Airspace Change – ACP-2022-025

Dolgellau Geophysical Survey

Summary Report

Targeted Aviation Stakeholder Engagement

Figure 12: Regional TDA Complexes. Proposed EG D298 – EG D298A (orange polygon), EG D298B (green polygon), EG D298C (Blue Polygon). Existing D217 & D201 (Red Polygons).

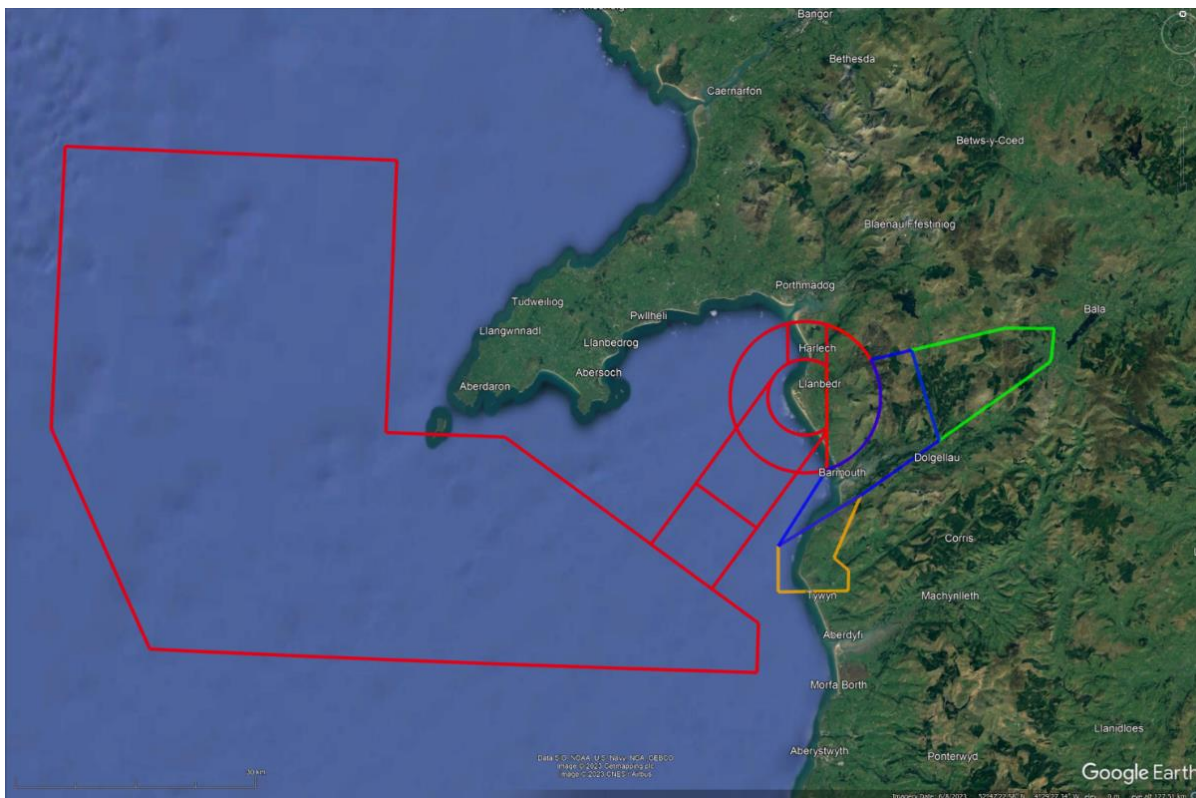
Following on the CAA ACP-2022-025 Targeted Stake Holder Engagement 25Jan2023-v2.pdf was distributed on 25th January 2023 and engagement with RAF Valley continued until 17th February 2023 when they approved our request for RAF Valley to operate as the Danger Area Activity Information Service (DAAIS) as Valley LARS on frequency 125.225MHz. NATS also agreed to provide an additional DAAIS service on London Flight Information Service (LONDON FIS) on frequency 124.75MHz in order to provide a more ubiquitous DAAIS service around the steep terrain of the proposed TDA.

The proposed TDA will not be activated if the Llanbedr Danger Areas D217C or D217D are active so that North to South and South to North traffic is not blocked, further reducing the impact to aviation stakeholders.

Figure 14: Map of TDA complex showing Operational Area in solid green, Contingency Area in solid orange and Emergency Buffer in solid red. Smaller red polygons denote geo-fenced exclusion zones over populated areas

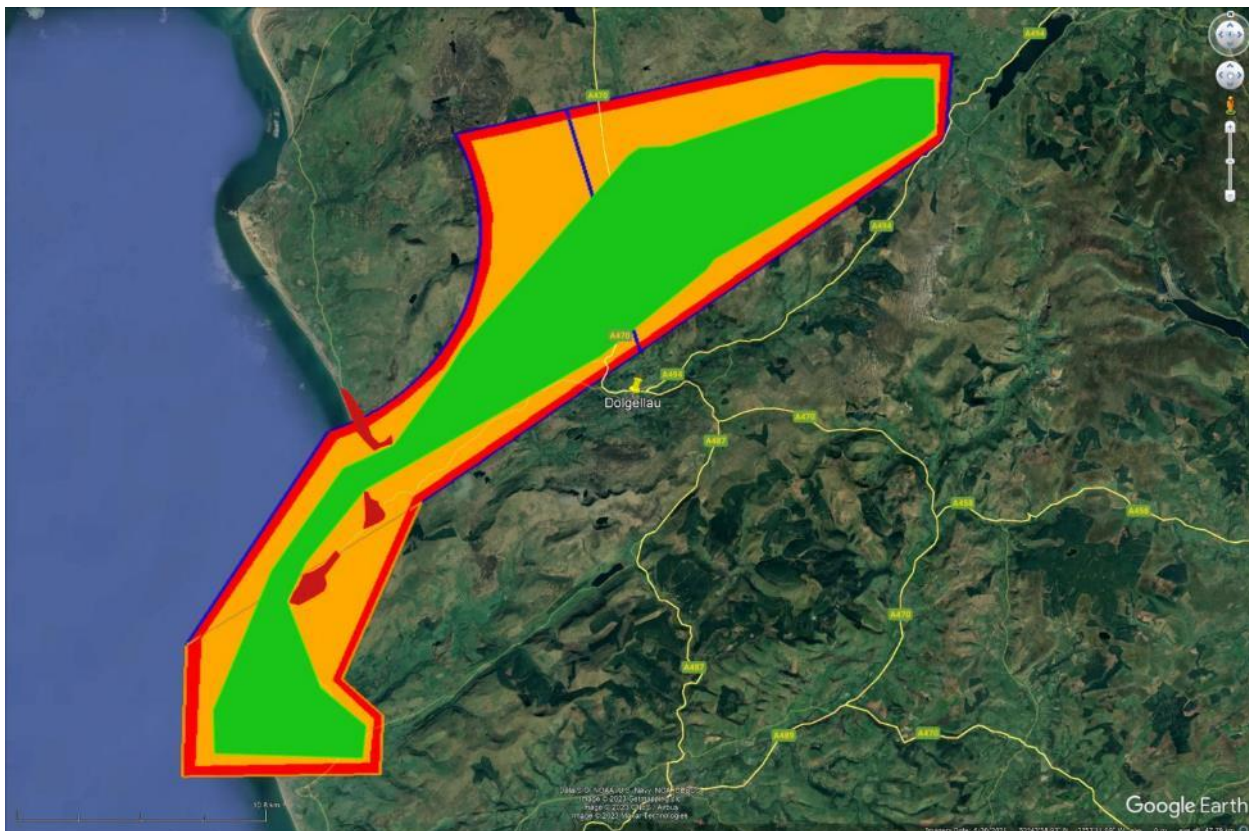
The TDA complex has an emergency buffer of 500m laterally and 500ft vertically built into the design. Therefore the UAV will not fly within 500m of 500ft of any other air-user flying along the TDA boundary. This Emergency buffer is marked in red on the map above.

The Operational Area, marked in green, denotes the area in which the UAV survey operations and transit to and from Talybont airfield are planned to be undertaken.

Figure 15: Map of TDA ALPHA (now EG D298B) and TDA CHARLIE (now EG D298C) showing location of loiter points

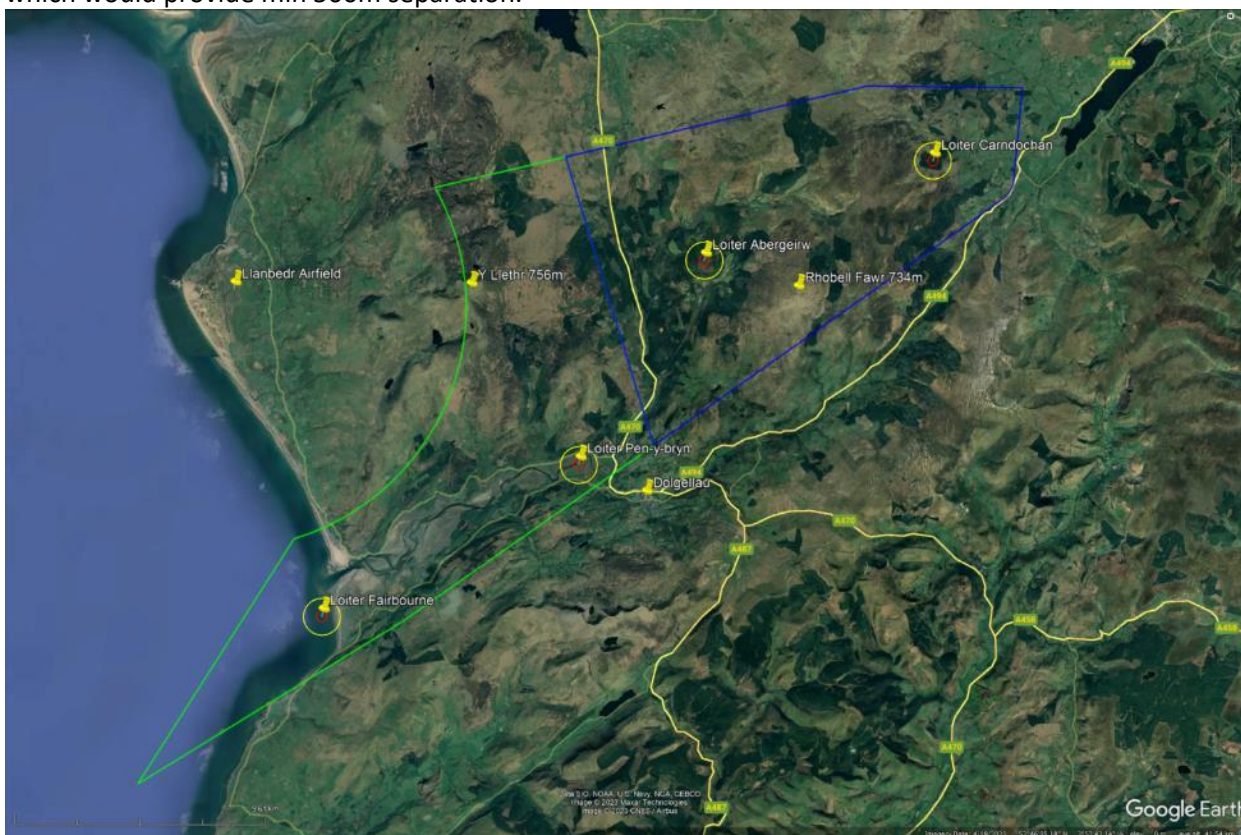
UAVE will put in place a network of 4 pre-agreed loiter positions at ~10km intervals which the UAV could reach within 7.5 minutes of notification where the UAV could loiter, in a 200m radius at 500ft agl, to enable a safe crossing of the TDA for NPAS, MCA, SAR or HEMS operations, if suitable UAV fuel reserves were remaining.

A map of suggested loiter points is below showing the 200m loiter radius in red and 700m radius in yellow which would provide min 500m separation.

Figure 16: Comparison of original proposed TDA ALPHA (Blue outline polygon) and the Revised EG D298B (Blue Filled Polygon) and EG D298C(green filled polygon) and comparison of original proposed TDA BRAVO (Pink outline polygon) and the Revised EG D298A (Orange Filled Polygon)

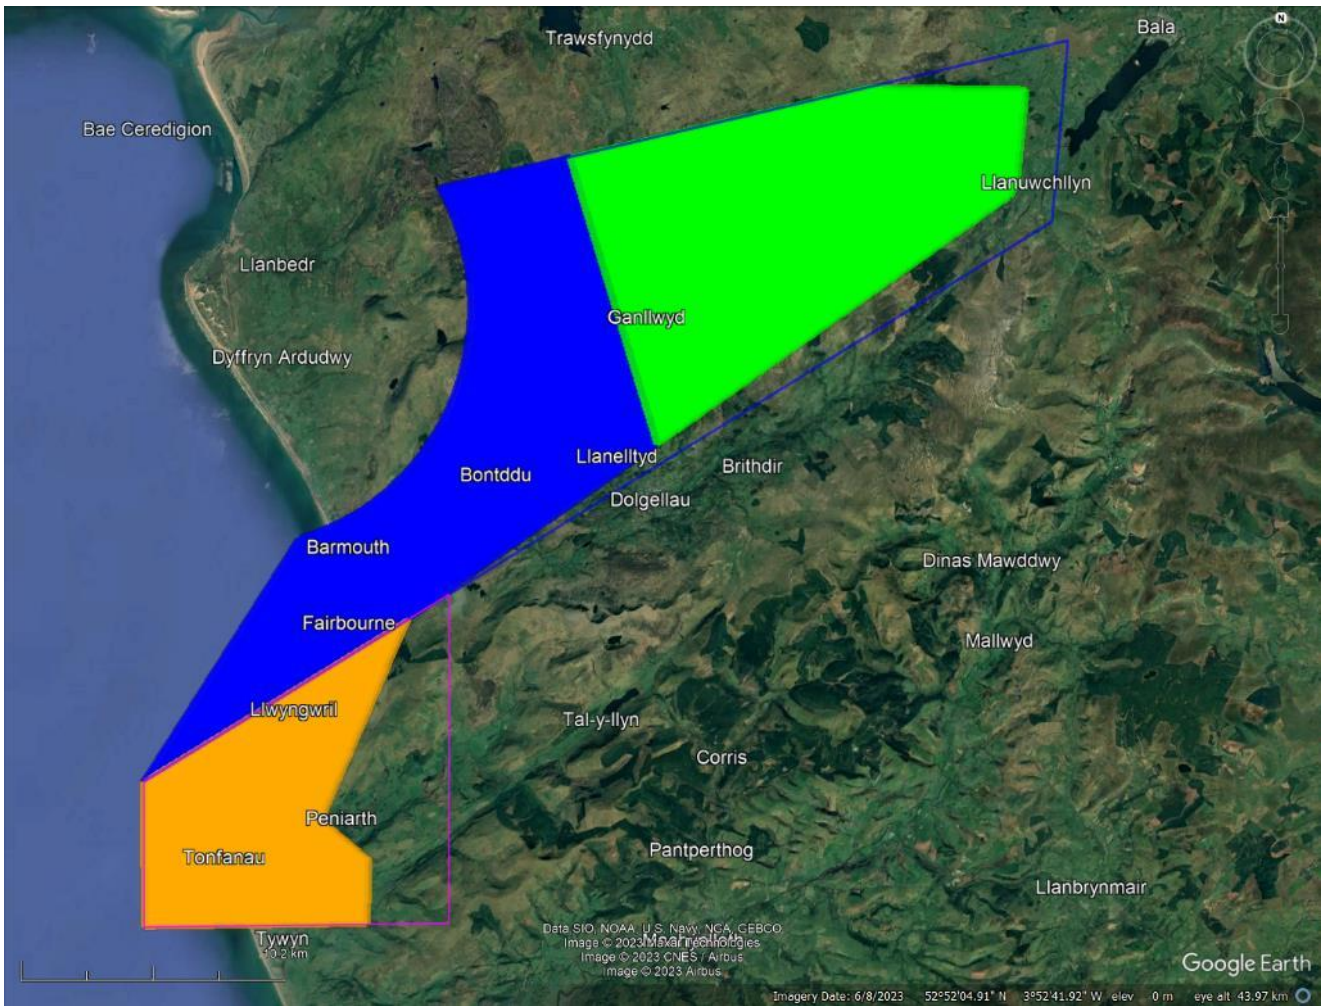
Following engagement, the original proposed TDA ALPHA (Blue Outline Polygon) has been reduced in size at the eastern end to provide low level access for RAF fast jet training and split into two areas now termed revised EG D298B (blue filled polygon) and revised EG D298C (green filled polygon). This means that when daily operations are planned solely within the revised EG D298B boundary the revised EG D298C airspace can be left open for normal access.

The original proposed TDA BRAVO (Now EG D298A) (Pink Outline Polygon) has been reduced in size along it's eastern border to provide access to Peniarth Estate Airfield (revised Orange filled polygon).

UAVE propose these TDA's will be notified by NOTAM's on a daily basis meaning only airspace required for the days UAV flights will be active.
